Product / Process Change Notification (PCN)

PCN #: PCN_IndCHSA_20220608
Affected Series: WE-CHSA; 7843331000, 7843331200

PCN Date: December 08, 2021
Effective Date: June 08, 2022

7843331000

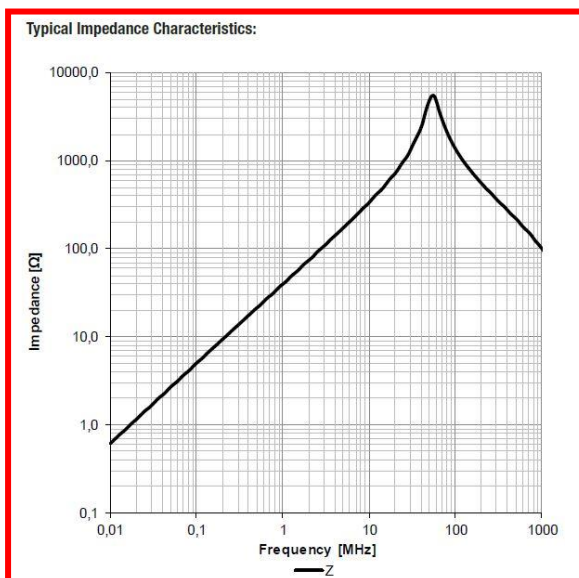
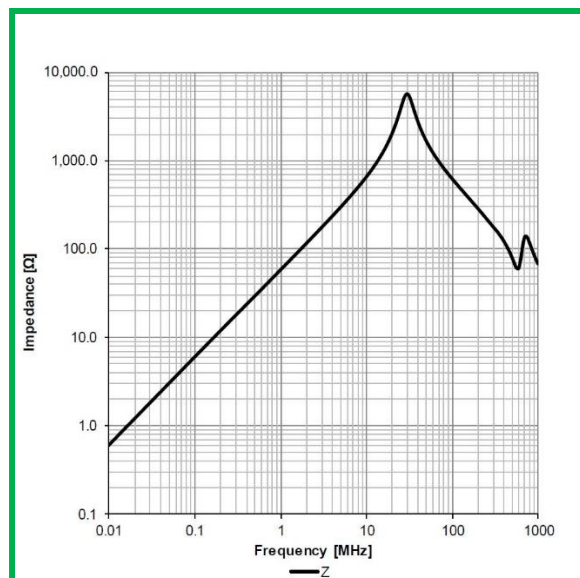
Because of a database mismatch, Würth Elektronik will update impedance graph in datasheet (Z vs f).

Before change:

After change:

7843331200

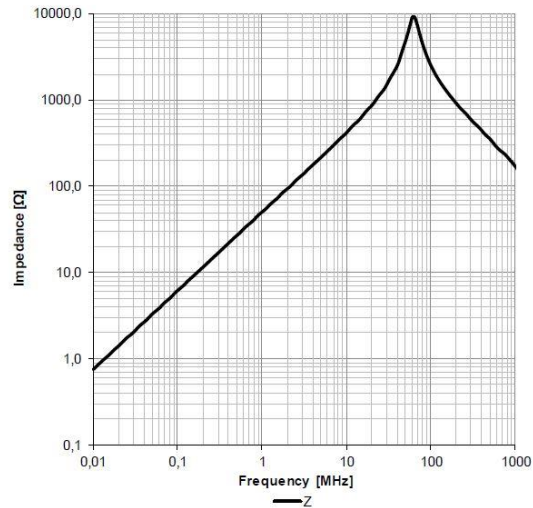
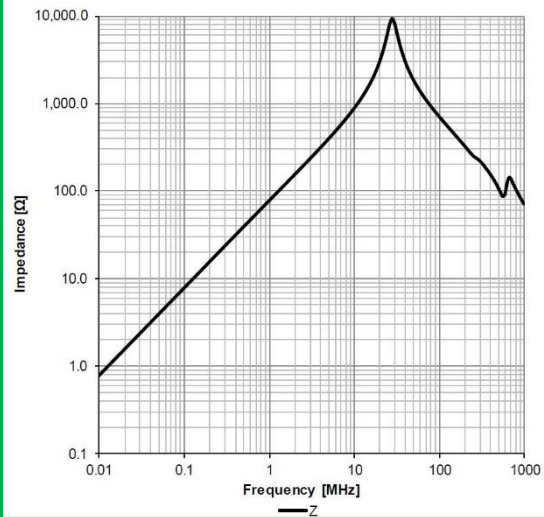
Before change:

After change
